Zoning & Subdivision Committee
Thursday, February 14, 2013 12:15 pm

JEROME VILLAGE GLACIER PARK NEIGHBORHOOD SECTION 2 PRELIMINARY PLAT

REQUEST: Approval of the Jerome Village Glacier Park Neighborhood Section 2 Preliminary Plat in Jerome Township, Union County

PROJECT NO.: 12017
 DATE: JANUARY, 2013
 SCALE: HORIZONTAL: 1" = 100'
 VERTICAL: N/A
 SHEET NO.: 4/29

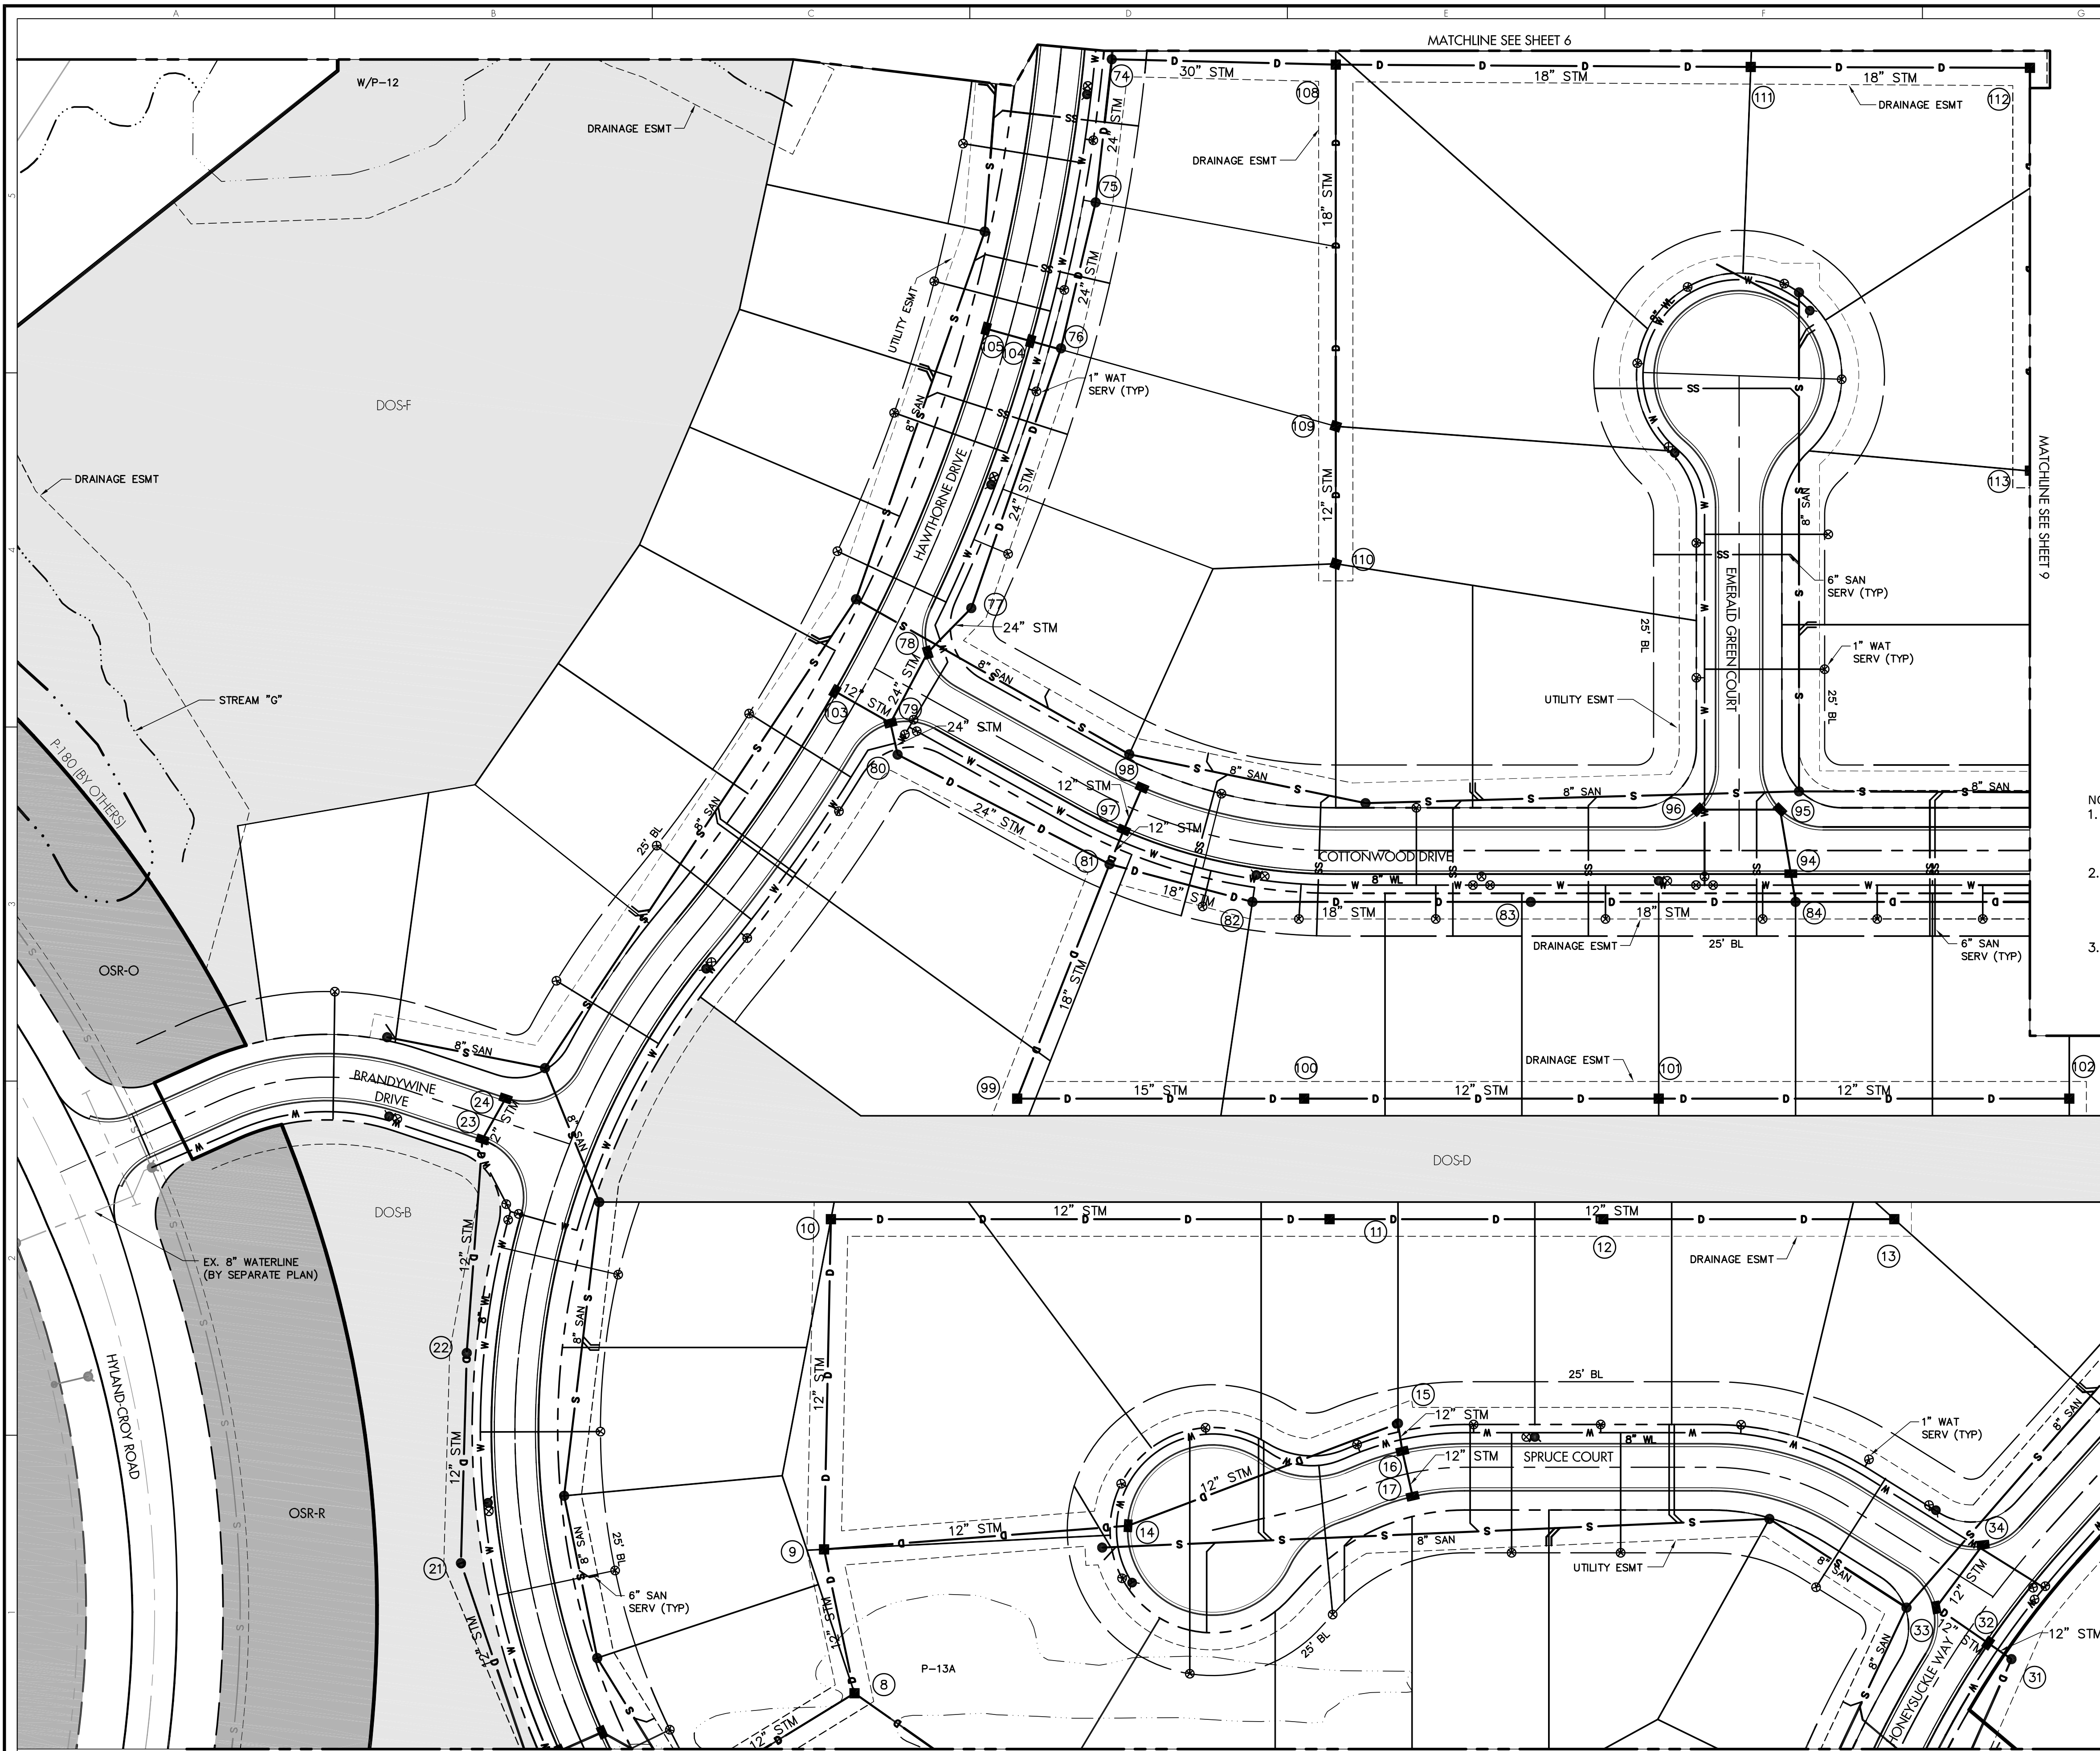
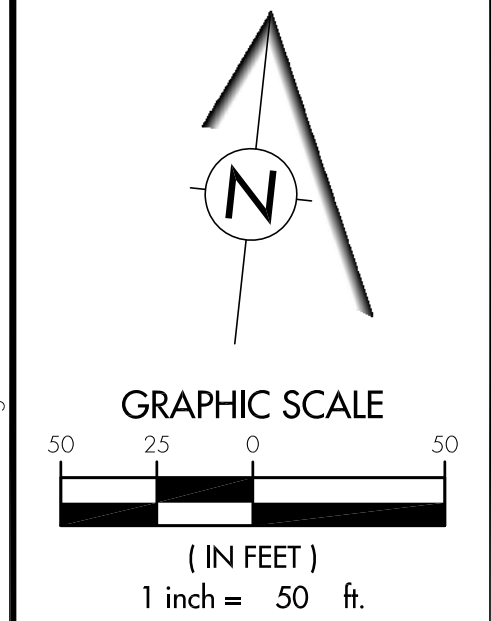
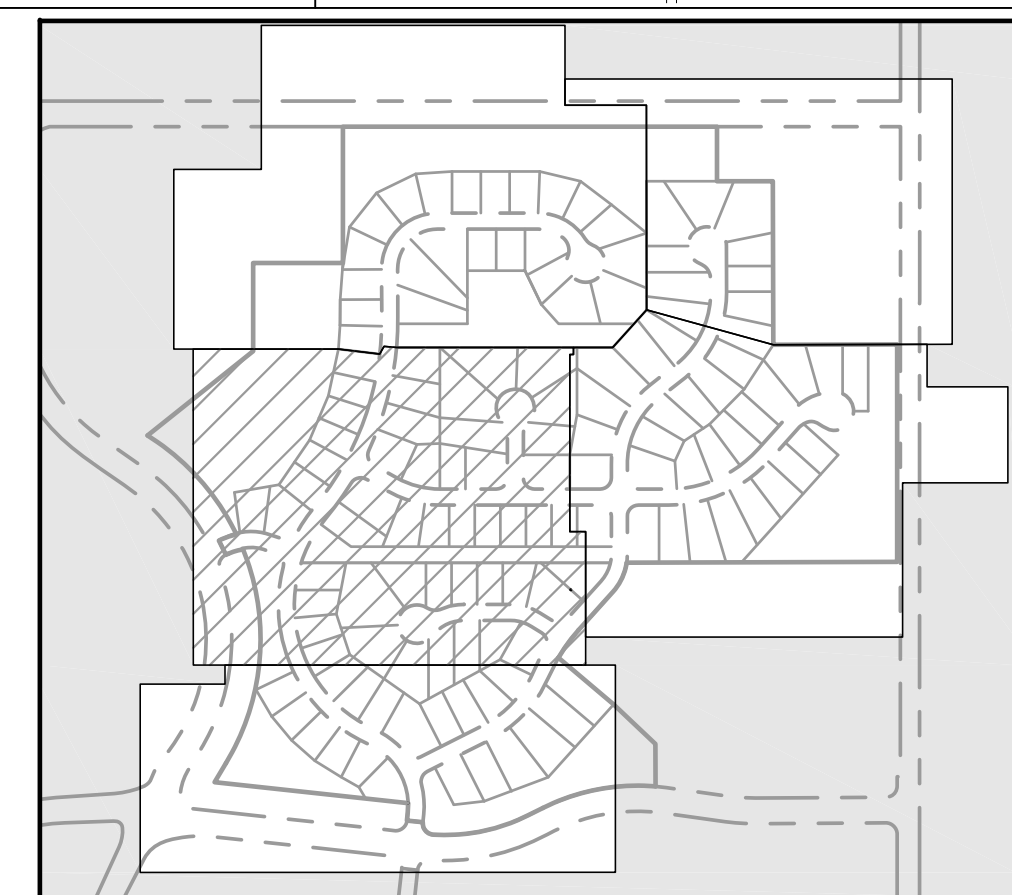
Preliminary Plat (Sheet 4):

1. Provide labels on the existing easements along Ryan Parkway.

SHEET NO.: 7/29

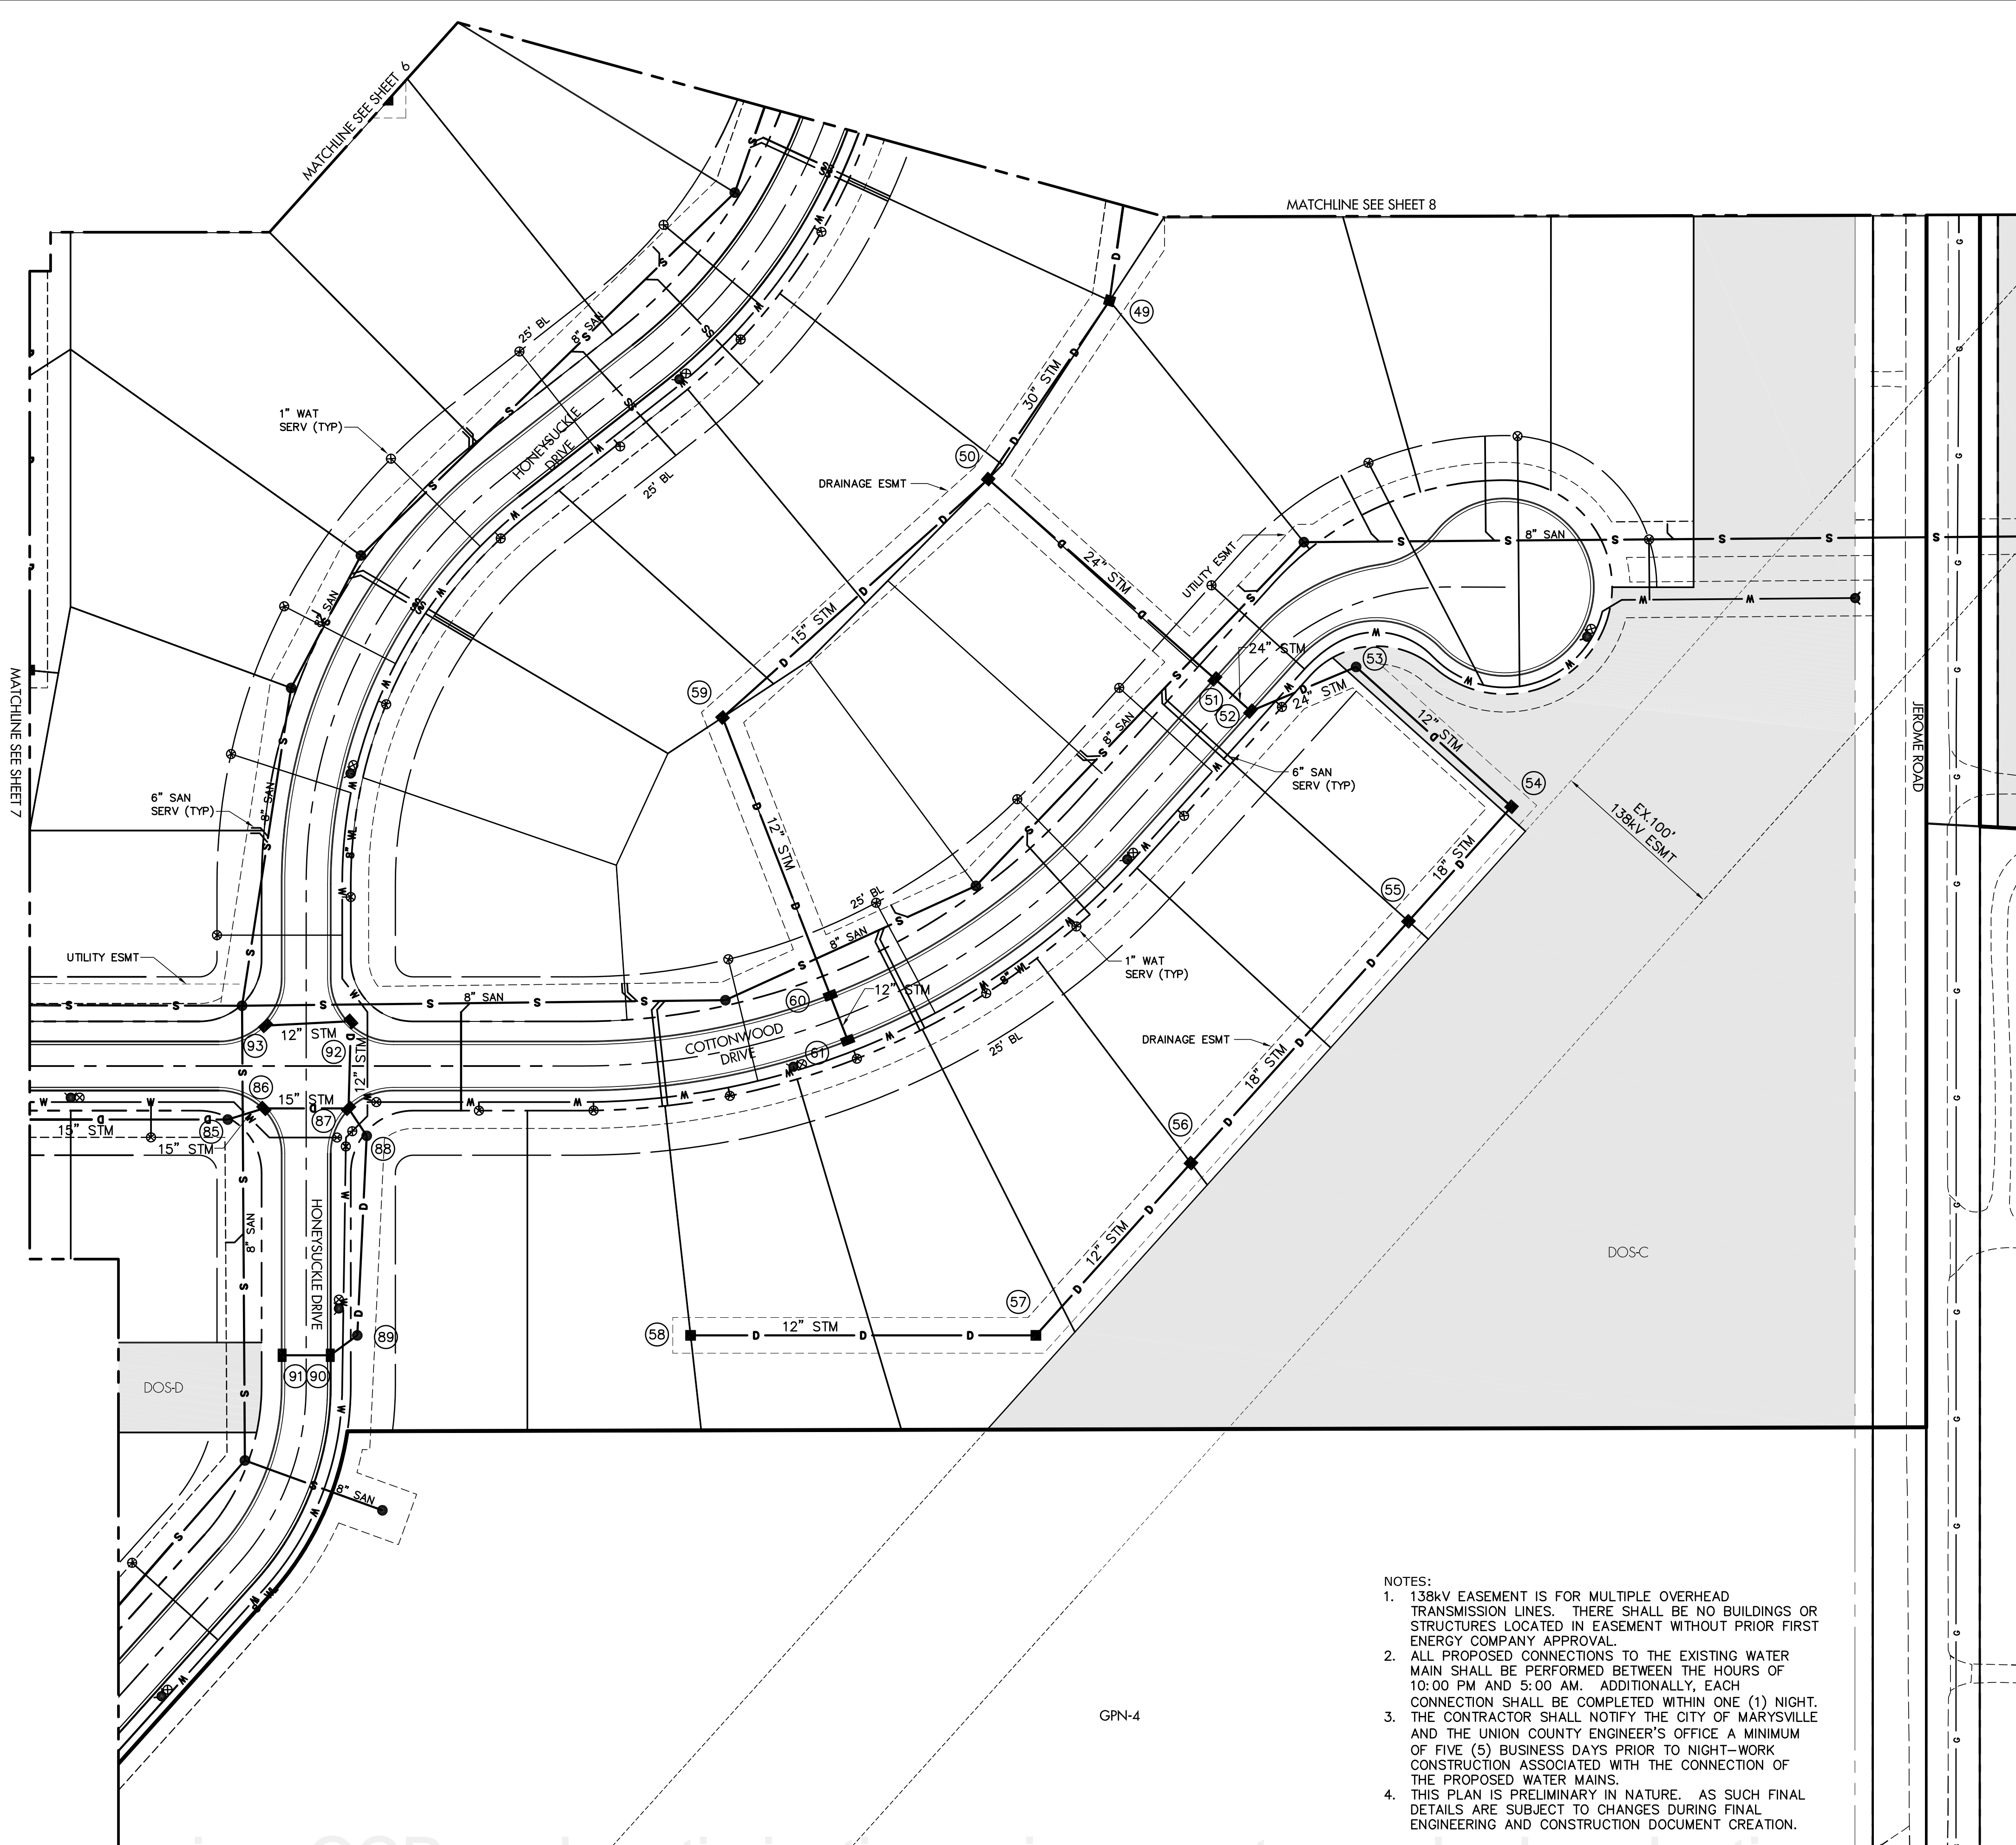
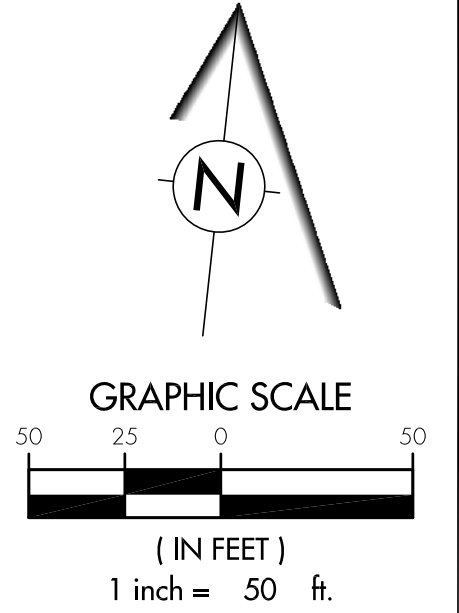
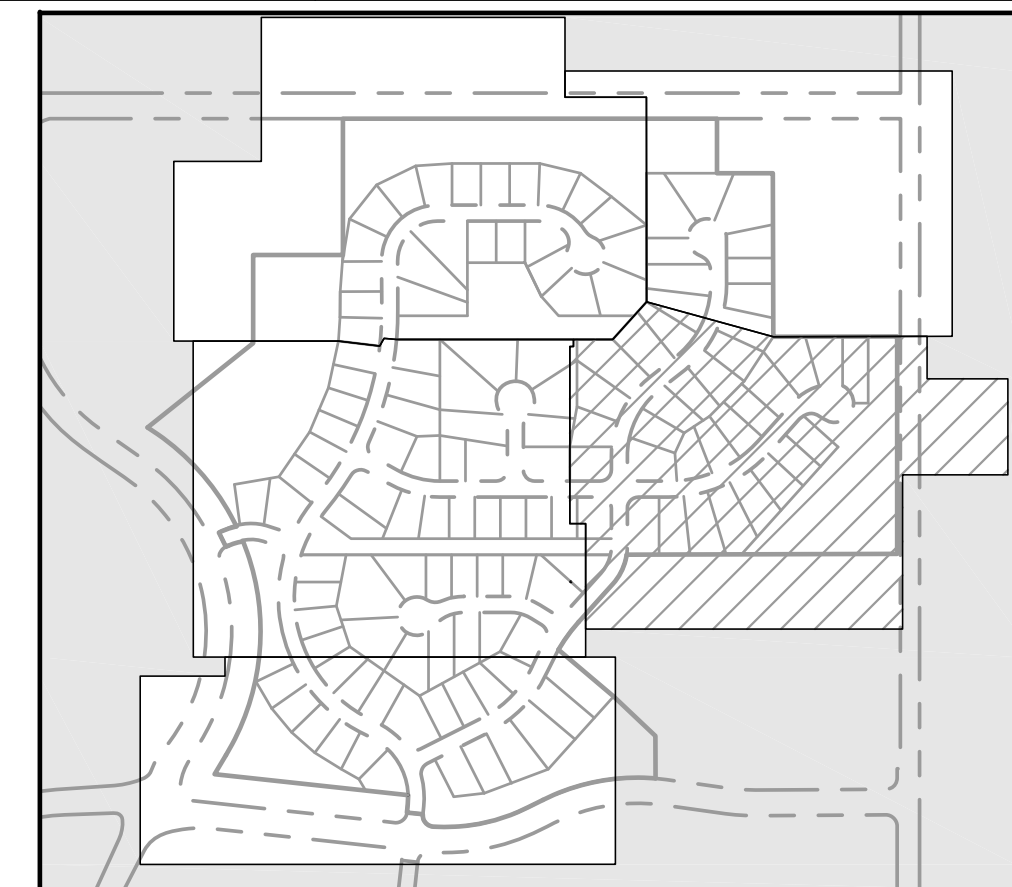
Detailed Composite Utility Plan (Sheet 7):

1. Several waterline appurtenances are "connected" to the right-of-way (near the Spruce Court Honeysuckle Way intersection and along Brandywine Drive). Please revise accordingly.
2. The northernmost valve at the Cottonwood Drive and Hawthorne Drive intersection shall be located north of Storm Structure #78 and outside the pavement.
